**ADDENDUM NO. 2 TO PROJECT NO. 44294**

**CONSTRUCTION WORK  
REHABILITATE AIRPORT AND JUDD ROAD INTERSECTION  
STATE PREPAREDNESS TRAINING CENTER  
5900 AIRPORT ROAD  
ORISKANY, NEW YORK**

October 24, 2012

**DRAWING NUMBER:** C-108  
SHEET 11 OF 22

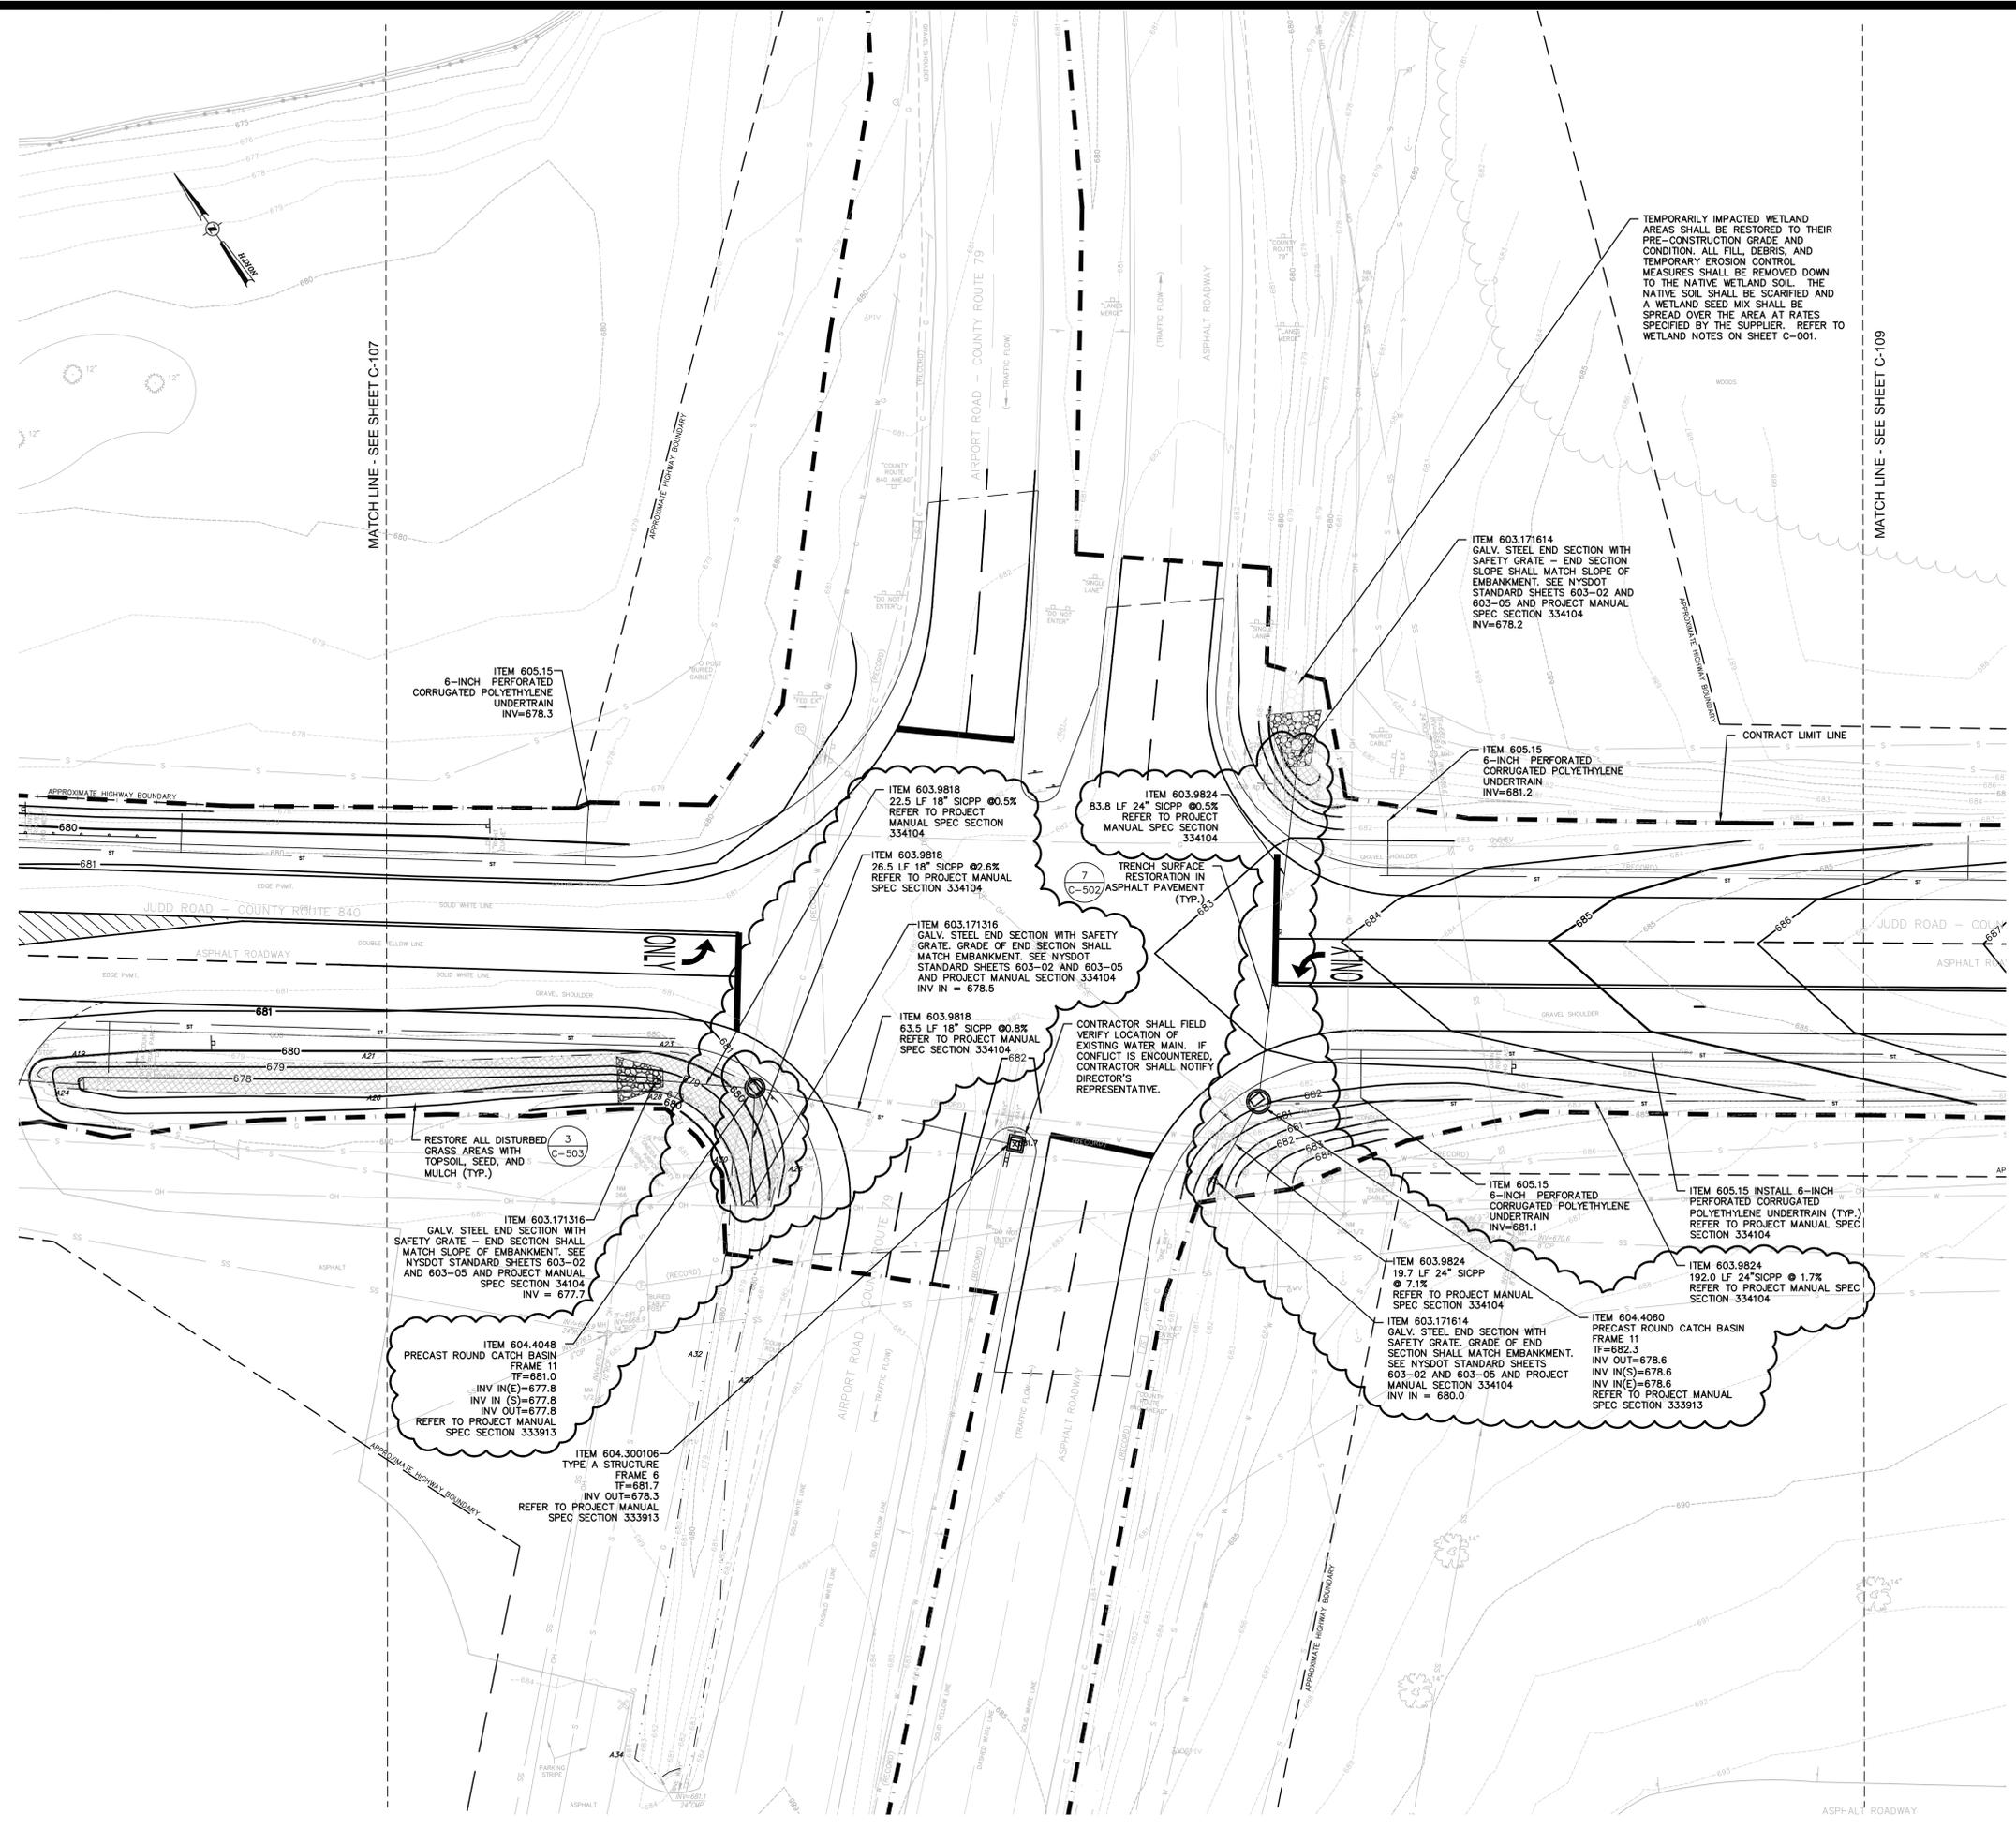
3. DRAWING NO. C-108 - GRADING, DRAINAGE AND UTILITIES PLAN
  - a. Delete drawing no. C-108 and replace with attached drawing no. C-108.
4. DRAWING NO. C-502 - SITE DETAILS, DETAIL 11/C-502 – CORRUGATED BEAM GUIDERAIL DETAIL
  - a. Revise Note 1 to read: "Guide rail shall be furnished and installed in accordance with NYSDOT standard sheet 606-07. Refer to this sheet for end assembly requirements."
5. DRAWING NO. C-504 - EVOC TRAINING COURSE ASPHALT REPAIR DETAILS, DETAIL 2/C-504 – TAXIWAY REPAIR DETAIL
  - a. Delete note "If existing asphalt pavement depth is greater than the proposed asphalt pavement section, increase proposed asphalt binder thickness to match existing."
